City of Detroit  
Inter-Departmental Communication

**RE:** Petition No. 1768-revised  
Requested Encroachments At Various Location Surrounding 1400 Woodward  
(With Outdoor Seating, Planters, Exterior Lighting, Hotel entrance Awning And  
Other Awnings) Bound By Woodward, John R., Farmer, And Grand River Ave

## **PROVISIONS FOR ENCROACHMENT For Petition 1768**

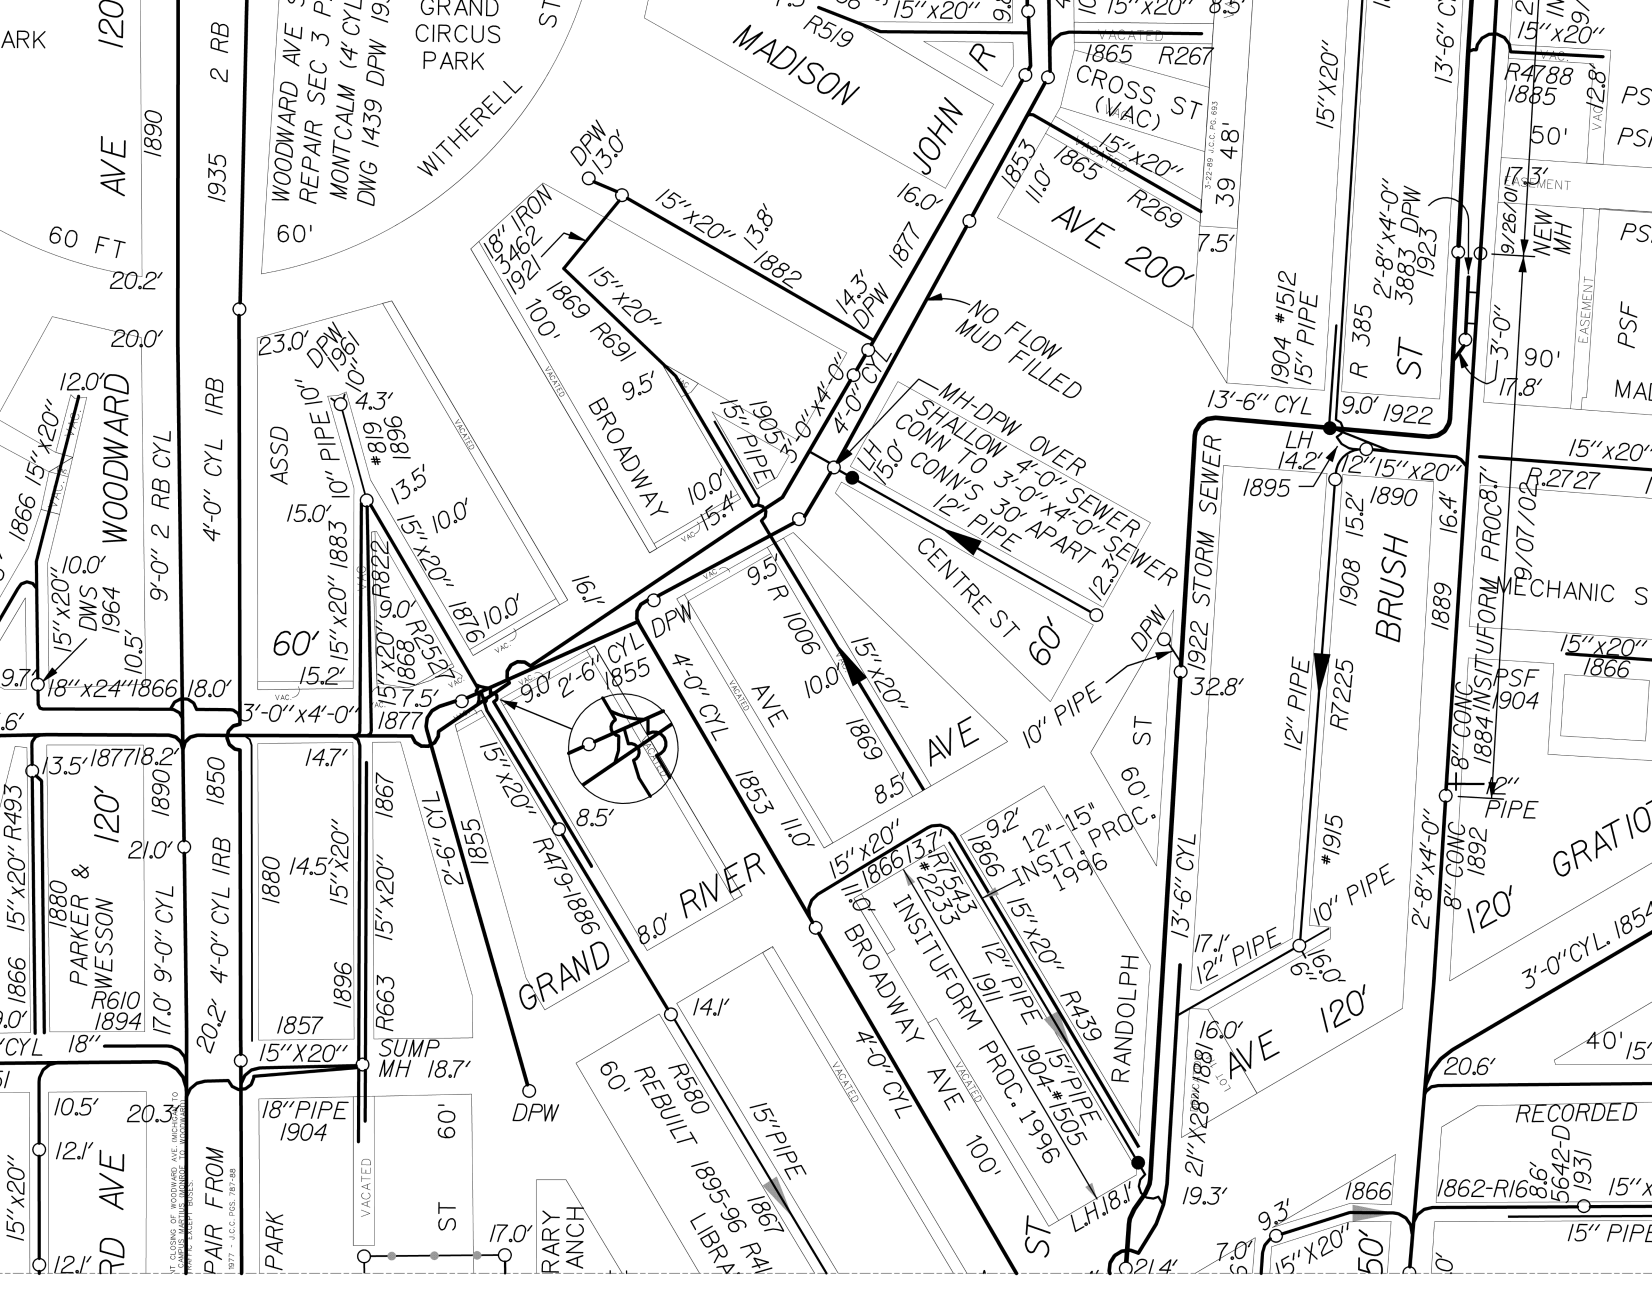
2. DWSD requires a vertical clearance of 18 feet above grade for maintenance excess and repair.
3. All construction performed under this petition shall not be commenced until after five (5) days written notice to DWSD. Seventy-two (72) hours notice shall also be provided in accordance with P.A. 53 1974, as amended, utilizing the MISS DIG one call system.

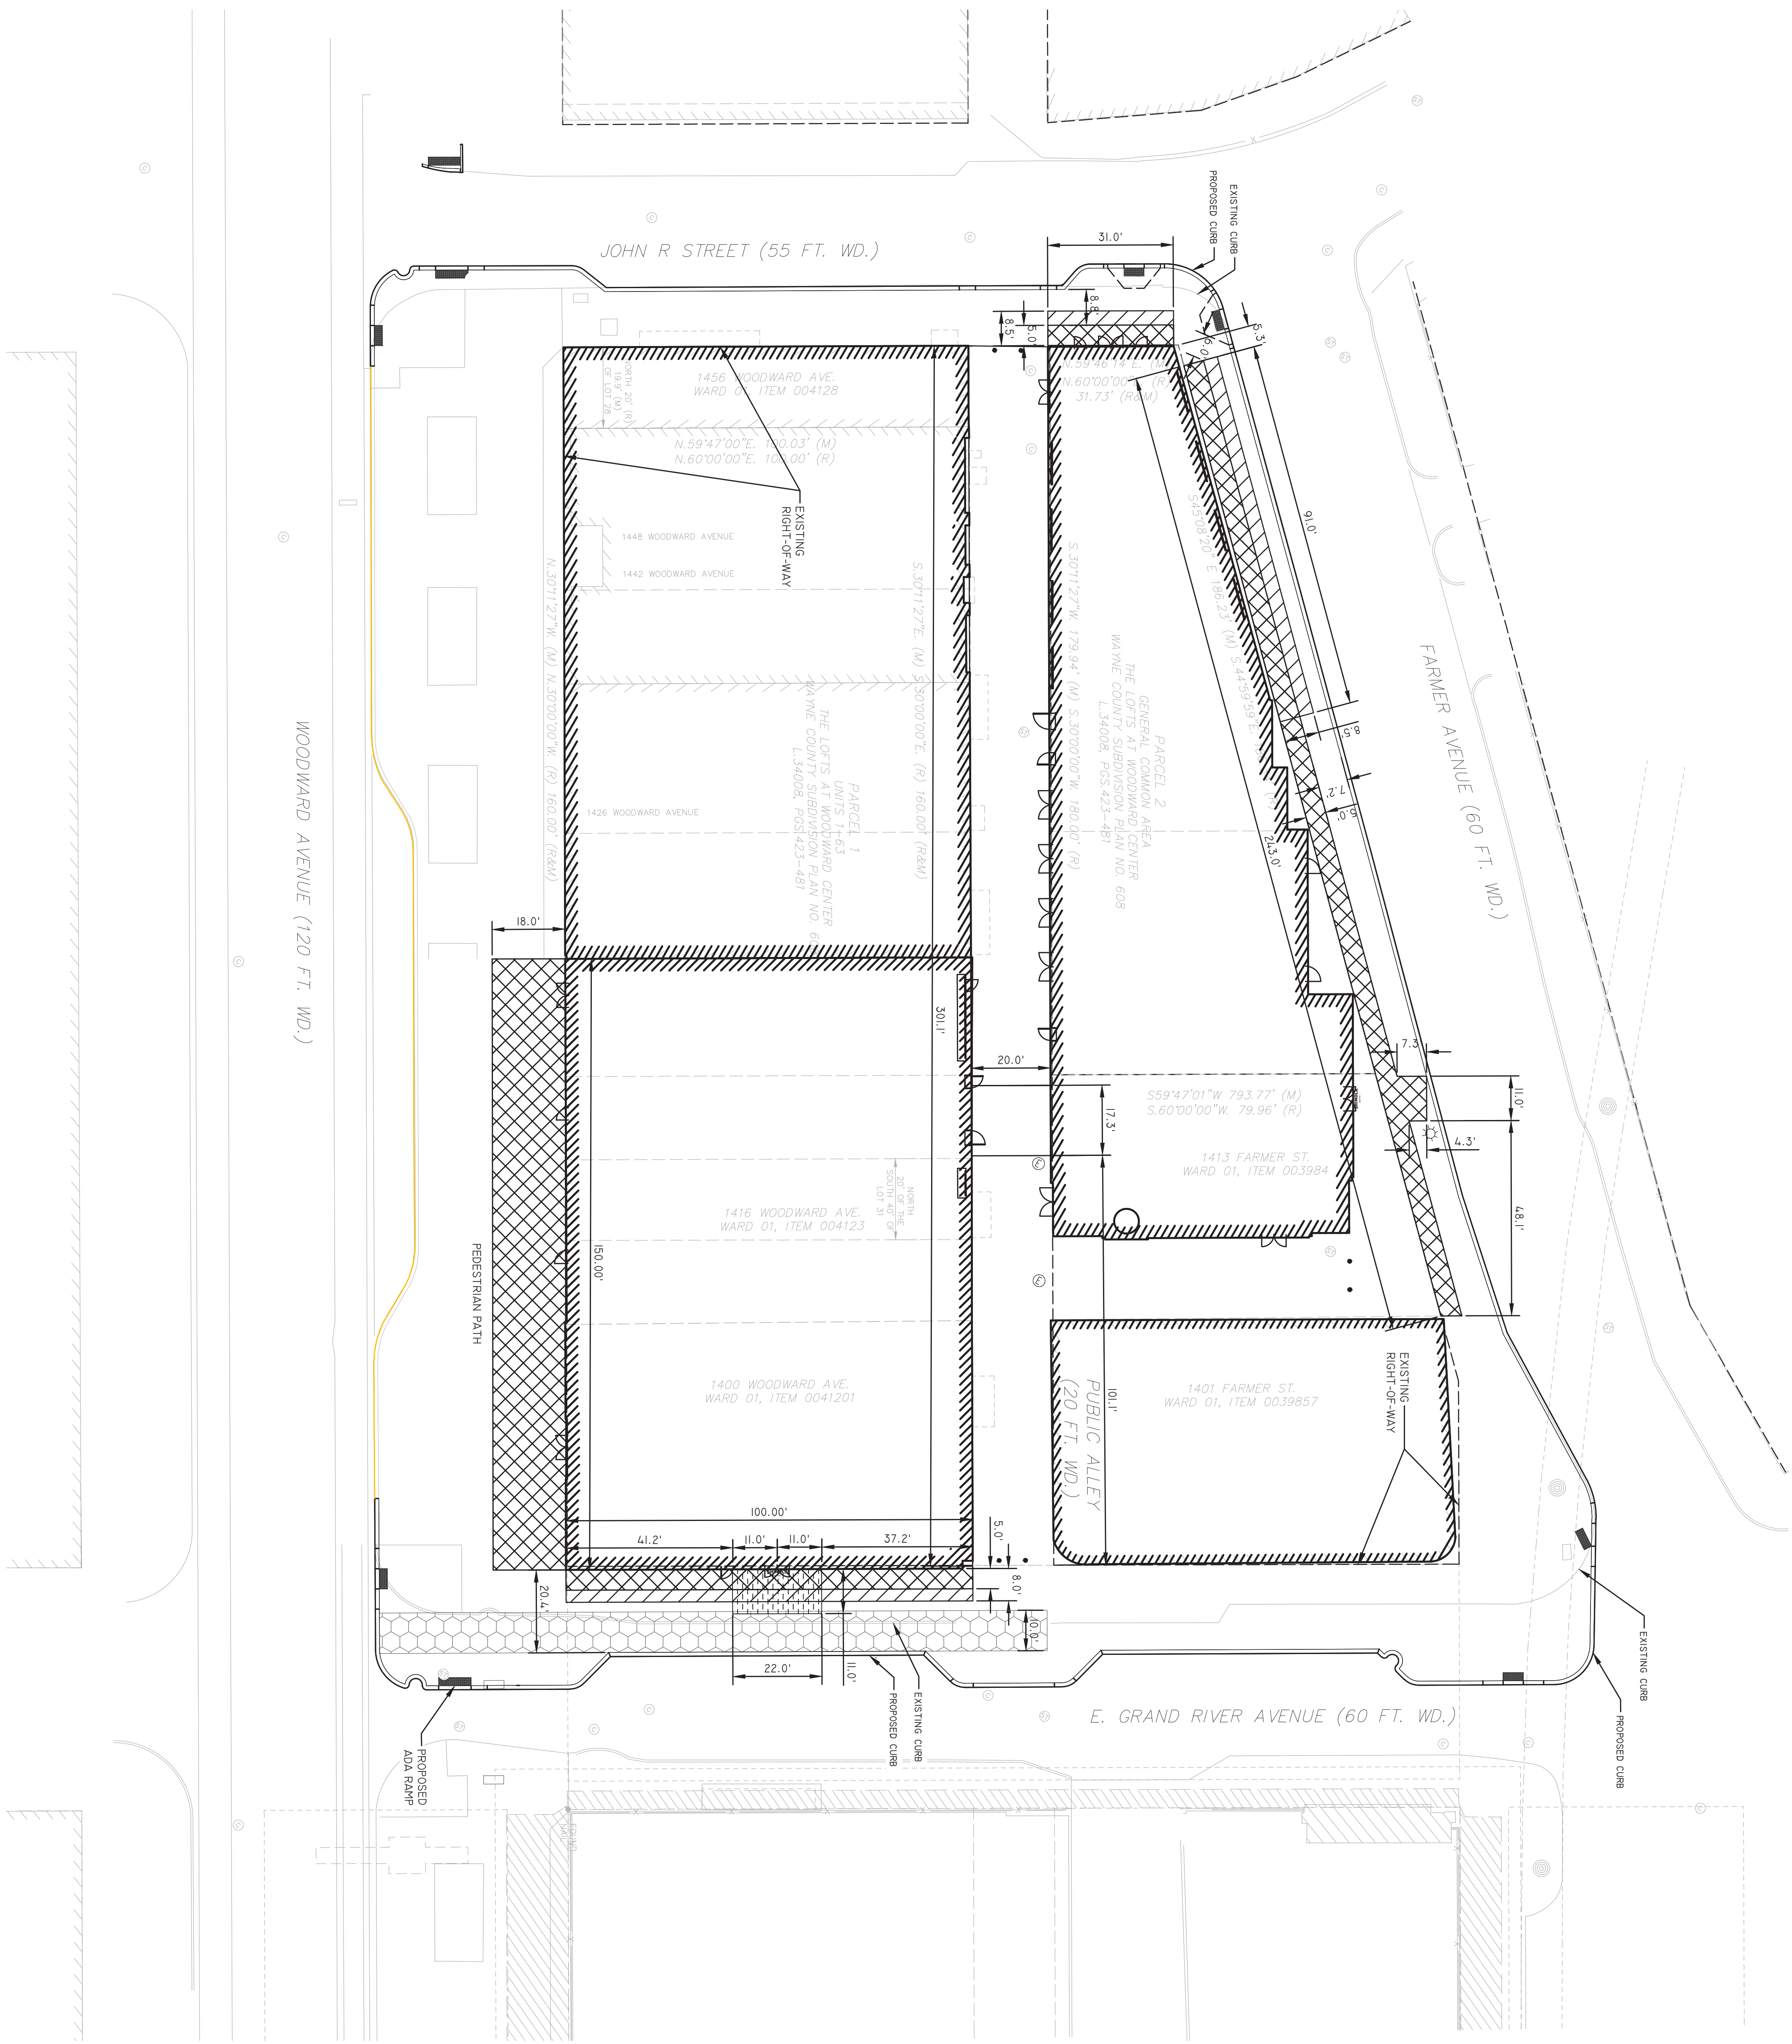
Per request from DWSD we need the mounting depth.

For encroachments such as the Petition 1819 where items are mounted into the ground, can the petitioners please be asked to provide the depth below ground of the mounted items not just the width/length/height?  
Thanks
